CITY OF  
**West Linn**

Subject: Appellant Packet Received for AP-21-02

# APPEAL of Conditional Use Permit

Re: Willamette Neighborhood Association Appeal Packet for AP 21-02  
*Appeal of Planning Commission Decision Athey Creek Middle School Conditional Use  
Application at Dollar St., File No.  
CUP-21-02/DR-21-04/WRG-21-02/MISC-21-04/VAR-21-01/VAR-21-06/LLA-21-02  
Hearing Date October 4, 2021*

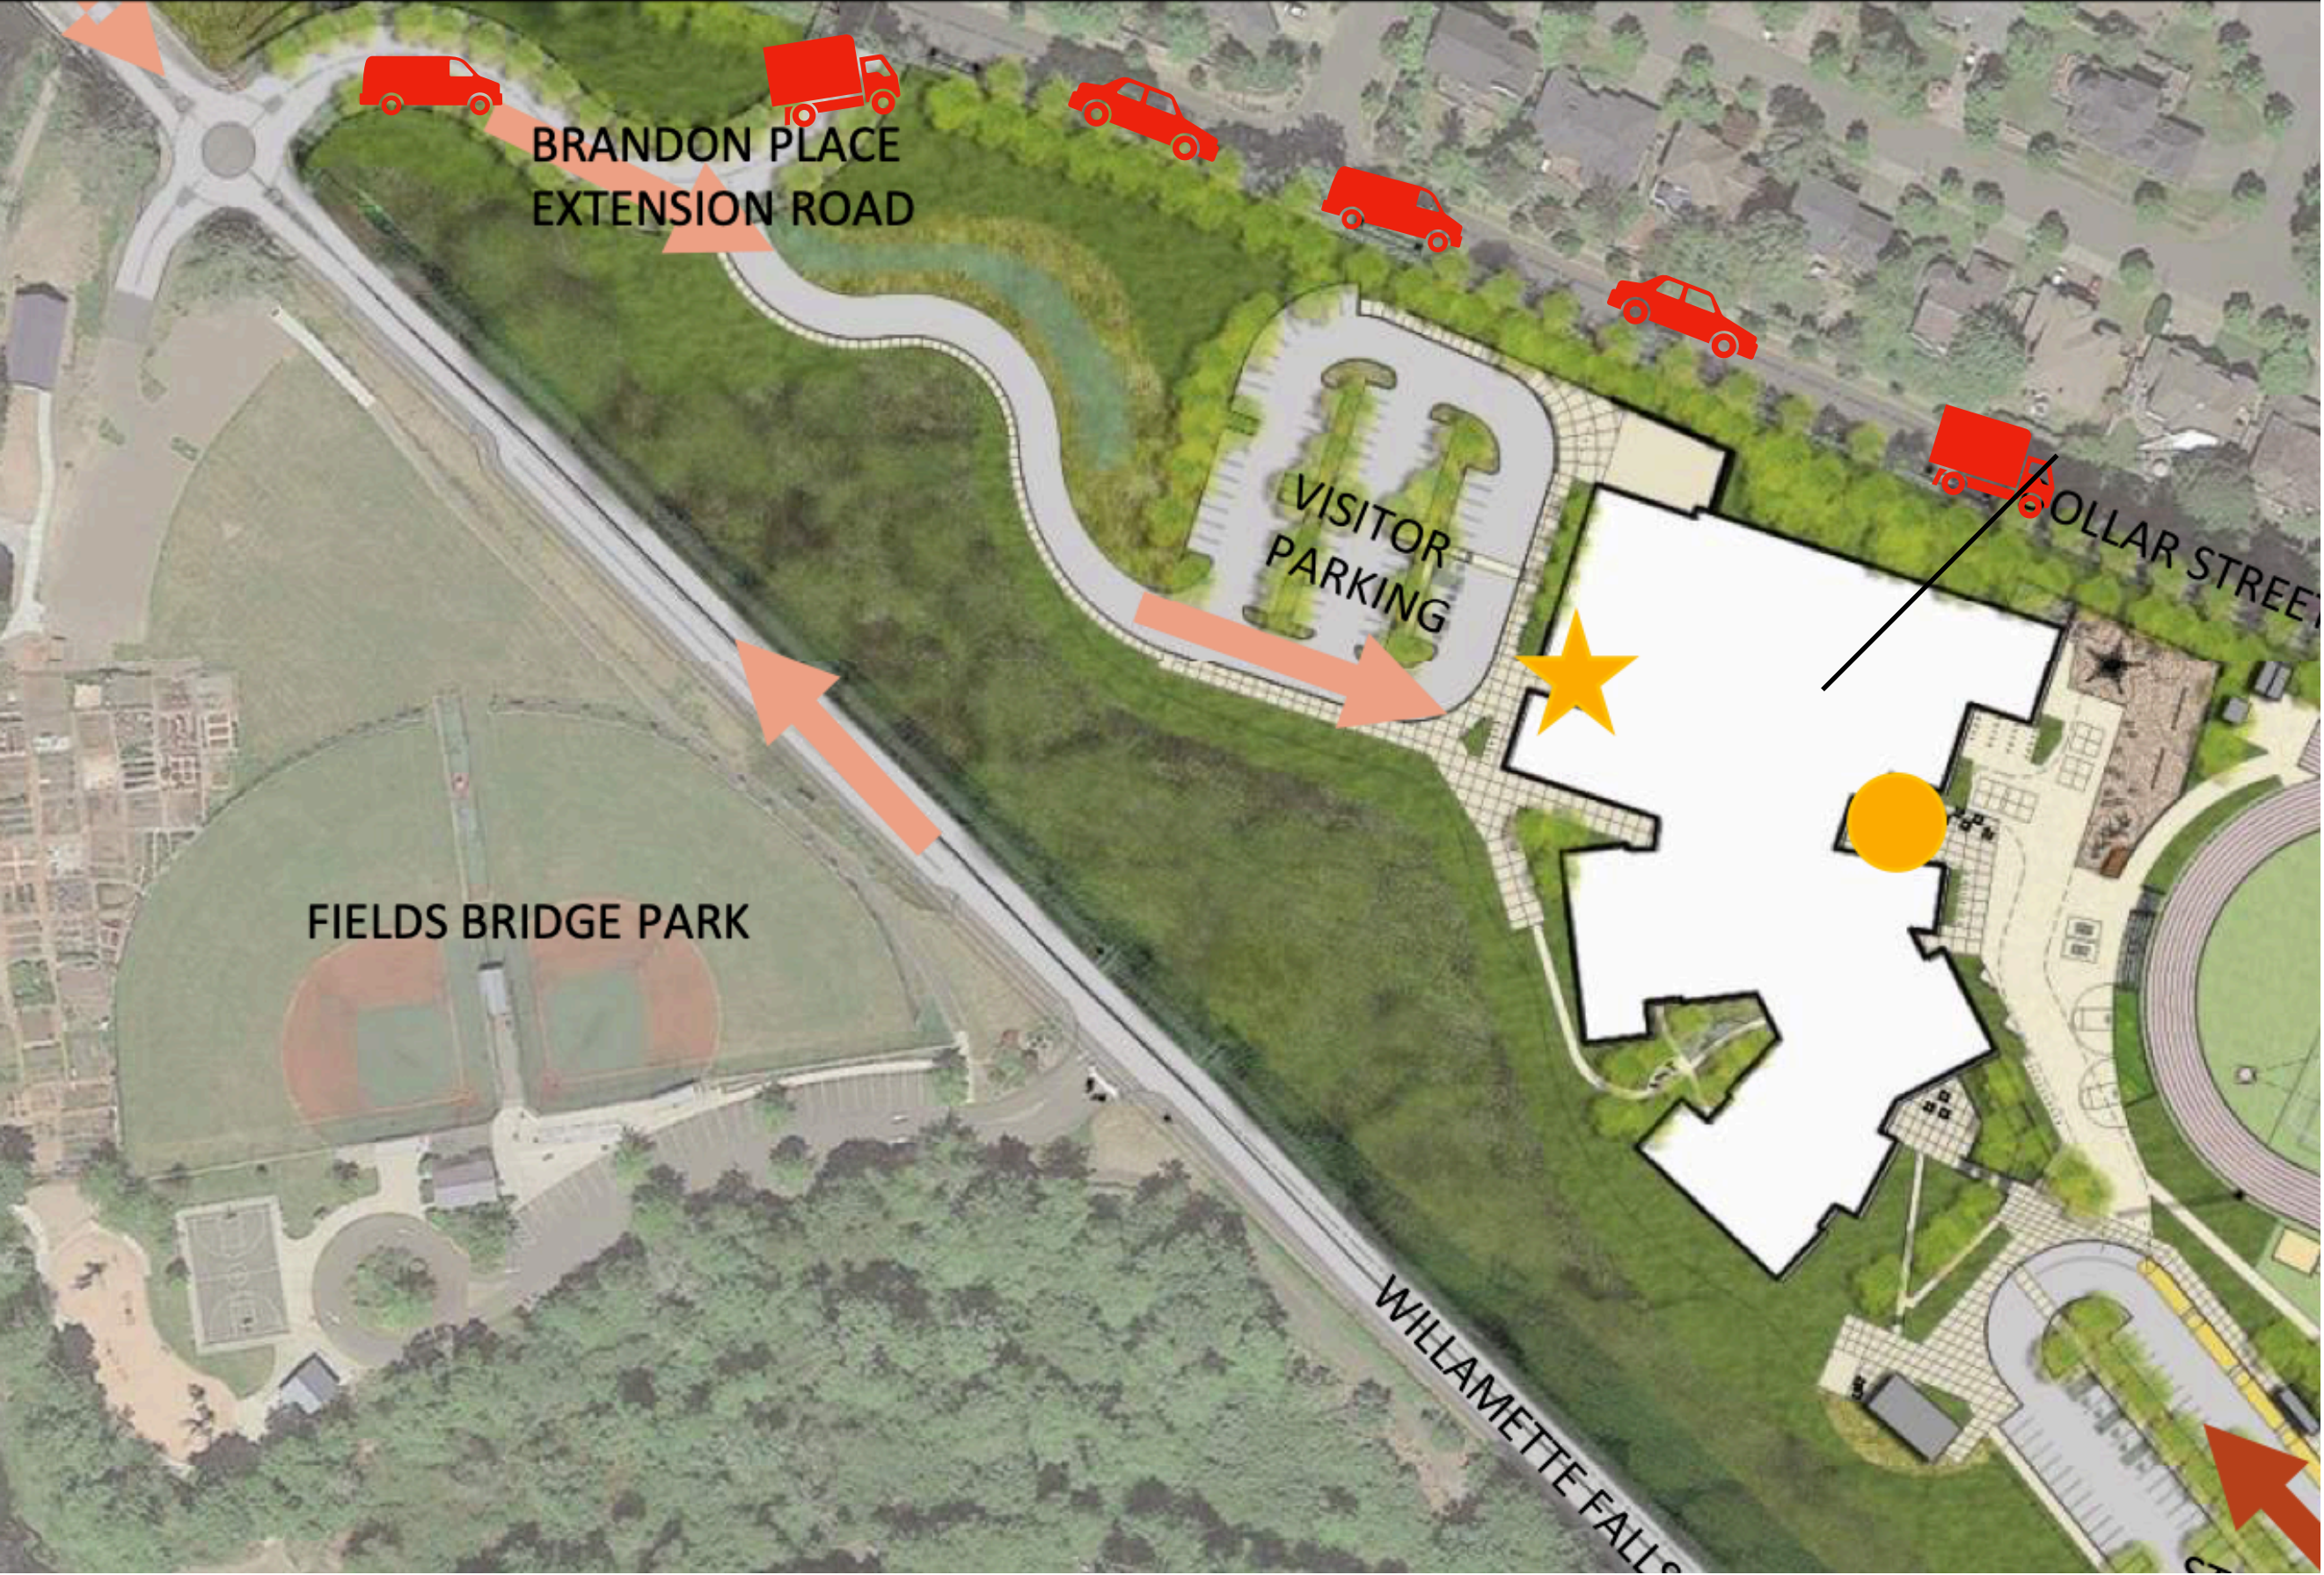
# Brandon Place Extension Dilemma

Per Application, WFD & Dollar St. to be connected for Public Use

✗ Excessive new trips on local street

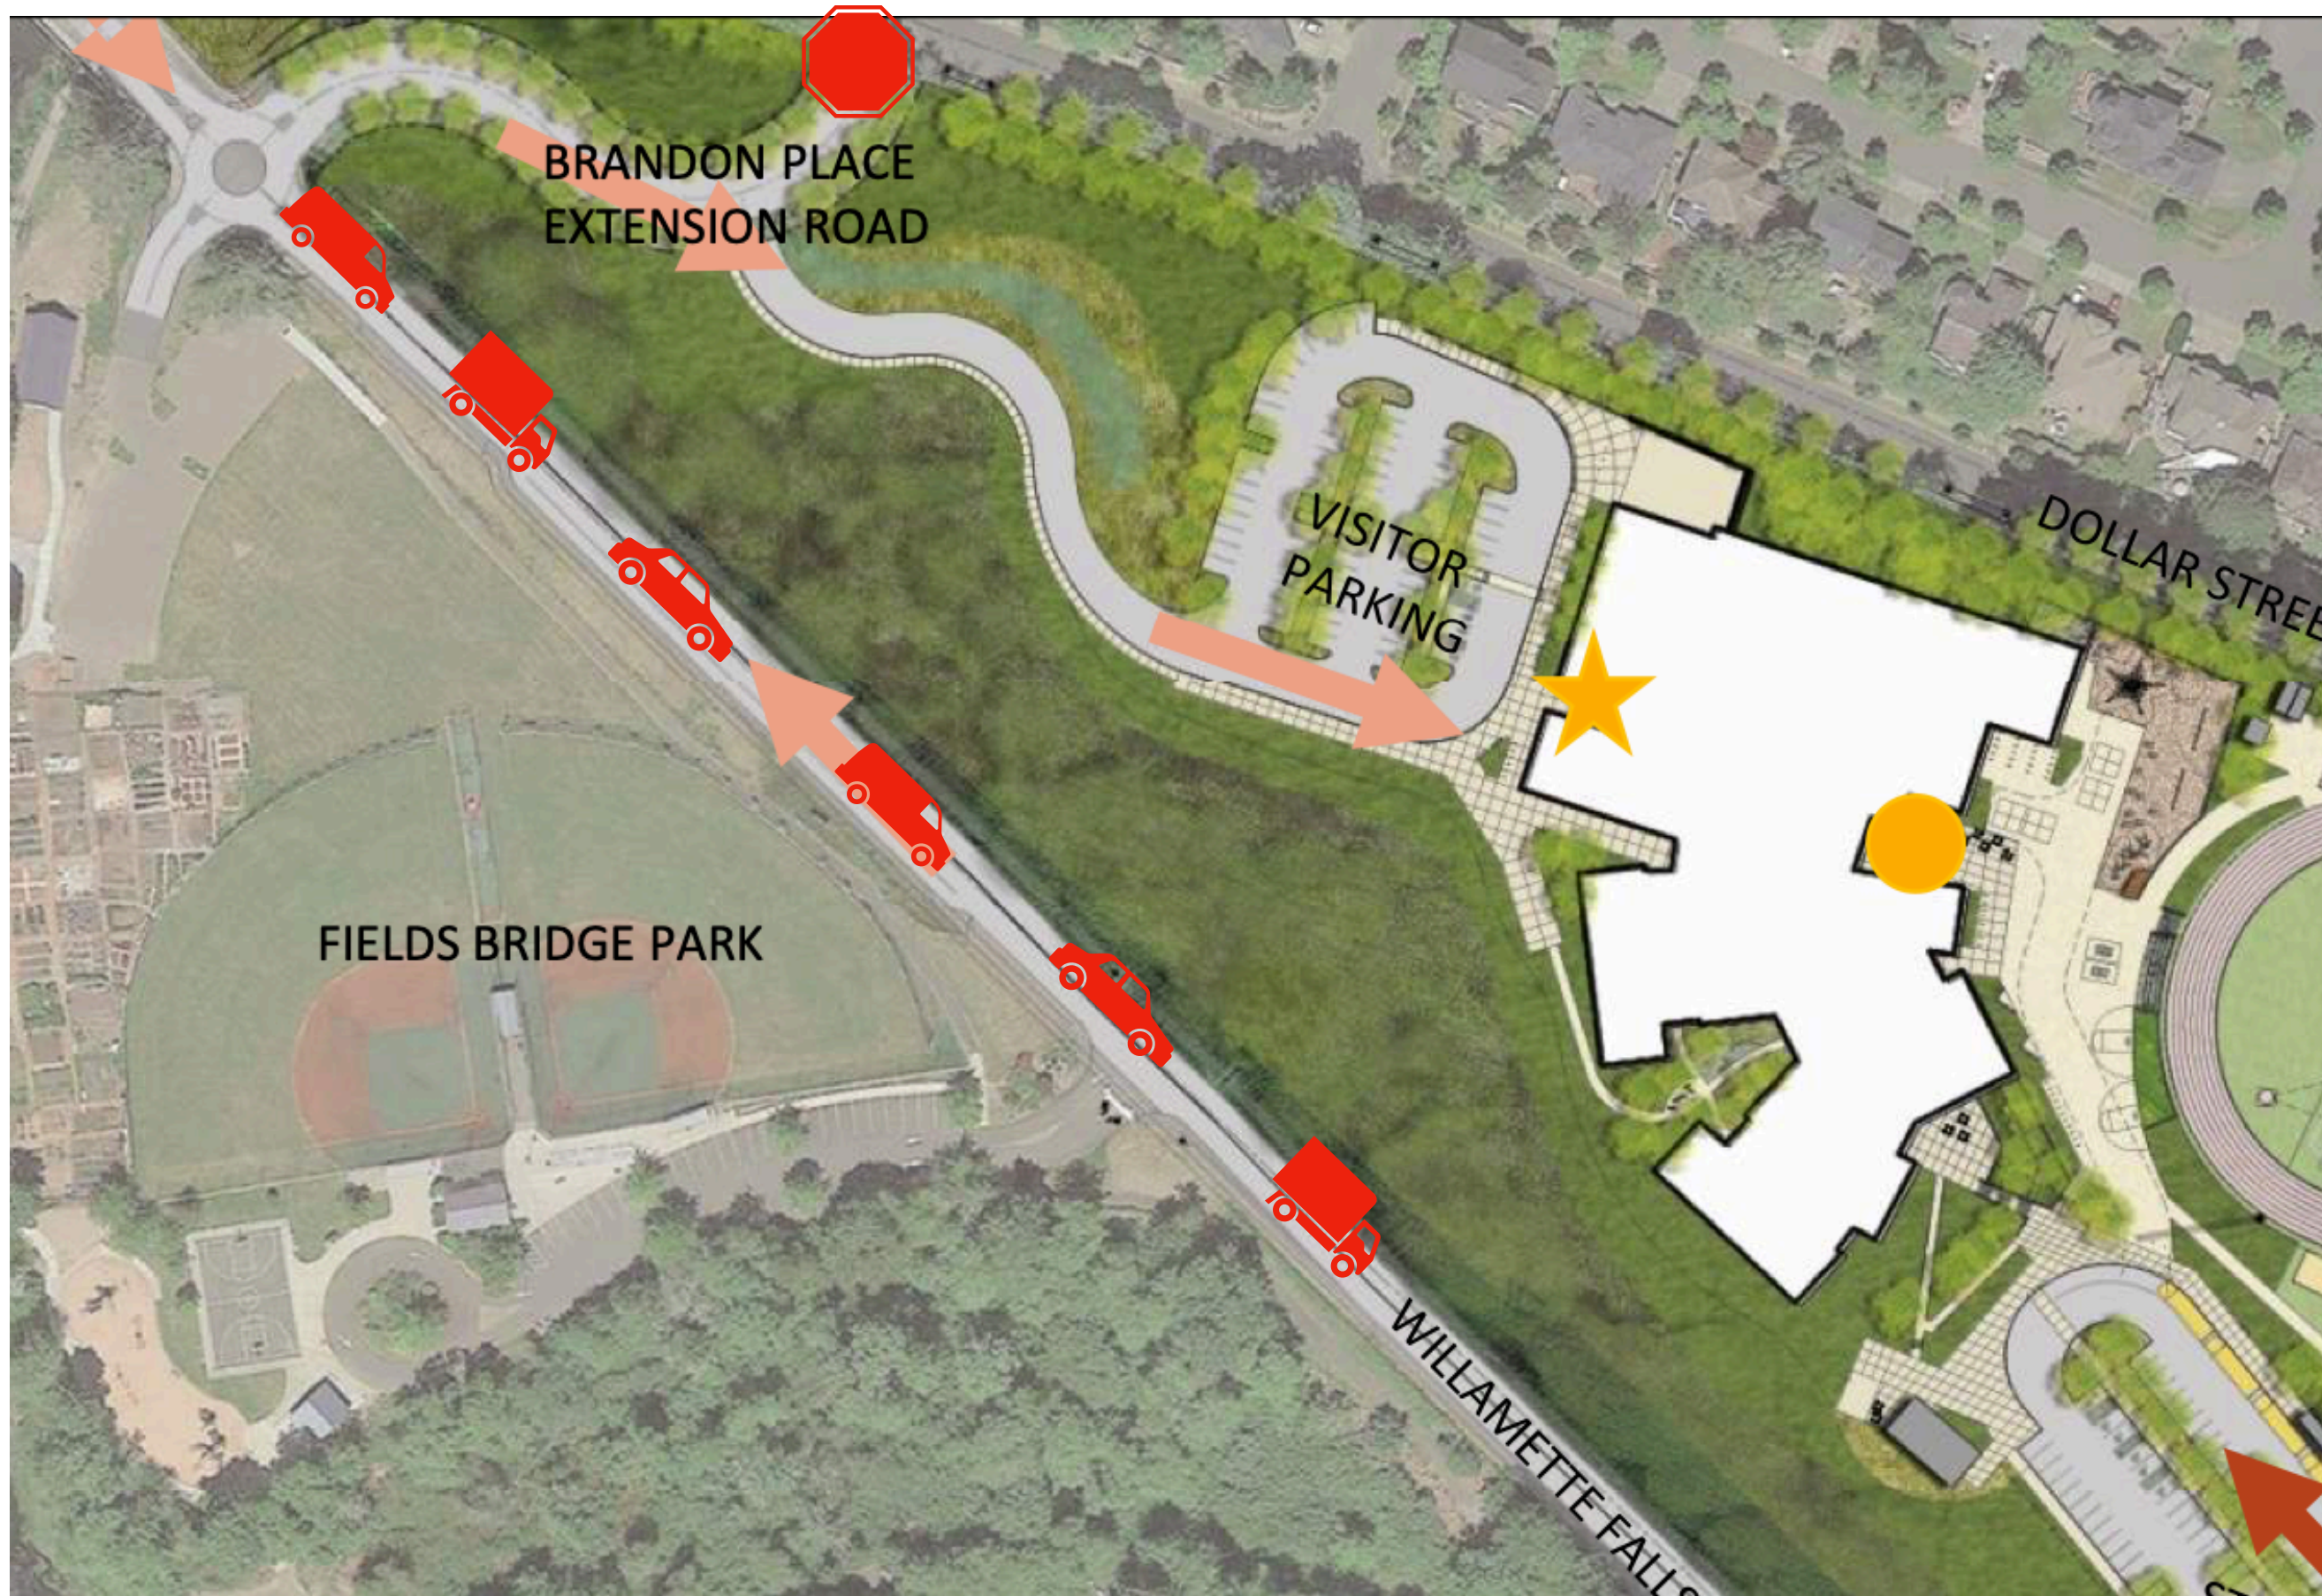
# Brandon Place Extension Dilemma

Per Condition 10, Extension closed to Public

✗ Fails TVF&R

Exhibit A – Dollar Street Neighborhood Access and Circulation System

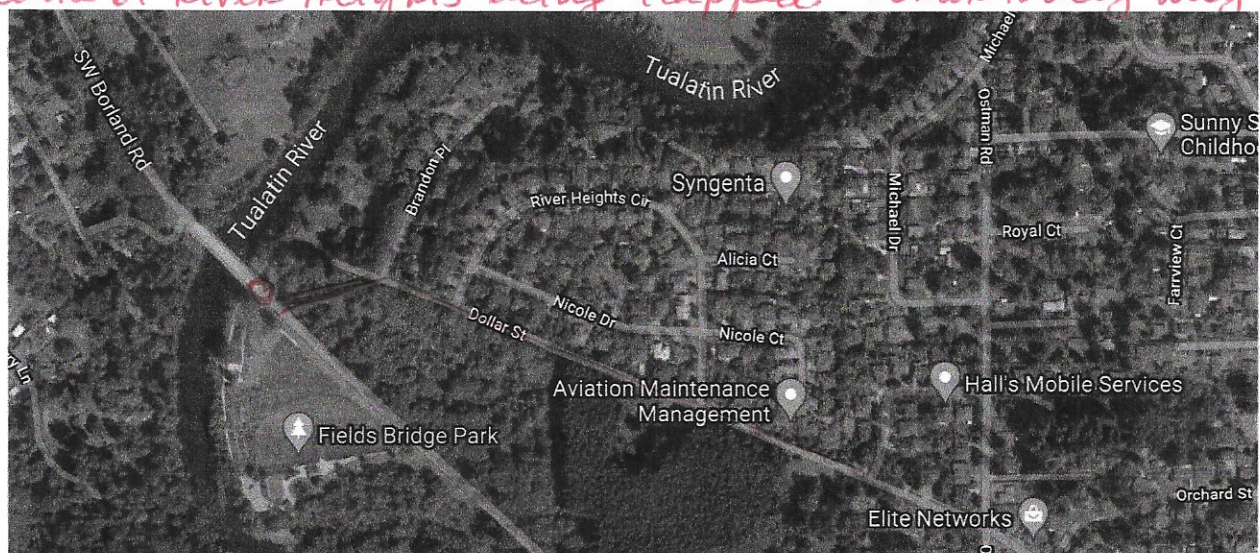
In assessing potential operational and/or safety issues associated with the net new trips introduced by the Brandon Place Extension, it is important to understand the characteristic of the roadways experiencing the change. In this case, the primary roadways experiencing traffic change are Dollar Street and Ostman Road (south of Dollar Street). The traffic within the neighborhood's immediately north of Dollar Street that are served by Brandon Place, River Heights Circle, Alicia Court, and Nicole Court will not have any net new trips introduced as there is no physical way to cut-through the neighborhoods due to the presence of the Tualatin River and cul-de-sacs restricting travel to/from the east as shown in Exhibit A.

*Wrong!*

*The concern is NOT traffic on those streets, but rather on Dollar, and residents of River Heights being trapped! Dollar is only way out.*

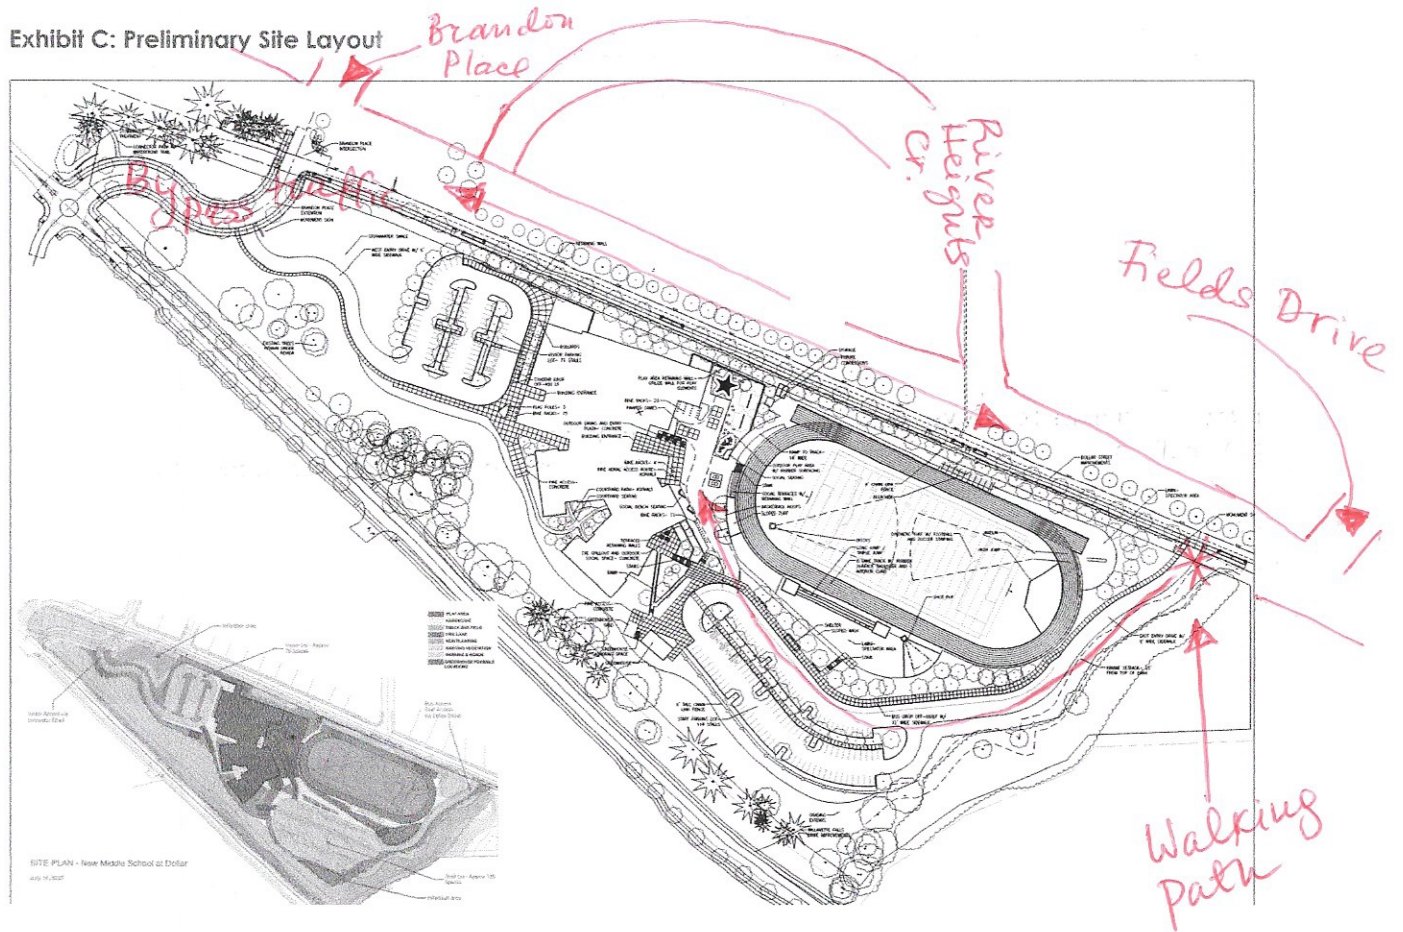
Neighborhood Student Drop-off <i>Looks like logic!</i>	Efficient <ul style="list-style-type: none"> <li>Parents will access Brandon Place via Dollar Street and access the school drop area.</li> </ul> <i>Again why would they pass the bus lane where the walking entrance is located?</i>	Circuitous Outcomes <ul style="list-style-type: none"> <li>Parents will drop students off along Dollar Street and allow students to walk;</li> <li>Parents will utilize the staff parking lot for drop offs; or,</li> <li>Parents will drive through the Ostman Road/ Willamette Falls Drive intersection to access the school drop area via Brandon Place.</li> </ul>

*Why would they drive all the way down to Brandon Place? The walking path is East!*

**FIGURE 4: APPROXIMATE PROPORTIONS OF TOTAL ENROLLMENT**

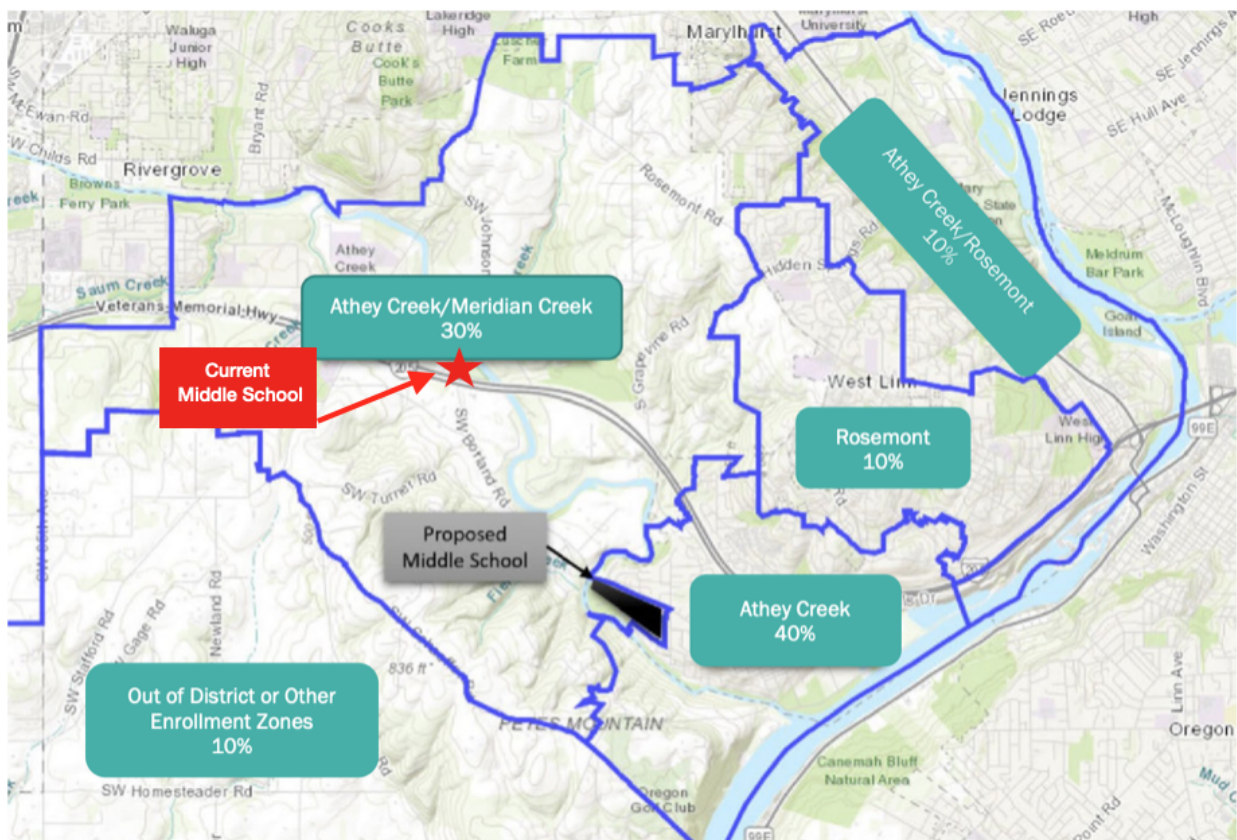
Additionally, only 41% of ACMS students in 2018 lived in the Athey Creek residence area-- a zone that encompasses a much larger area than the proposed 1 mile walking radius and extends south of the Tualatin River and north of the 205 (see Figure 4 below) . By contrast, the vast majority of students live on the far north-east side of town or the expansive Meridian Creek-ACMS choice area. For these students, the current site is just as close, if not closer. (See 2019 WLWV Long Range Facilities Plan, Flo Analytics Report, Figures 13 & 28.) Also, the new site will not be more accessible given traffic. Previously, students from these areas could access the middle school from the north and west side of town, but now they will be forced into Willamette traffic.
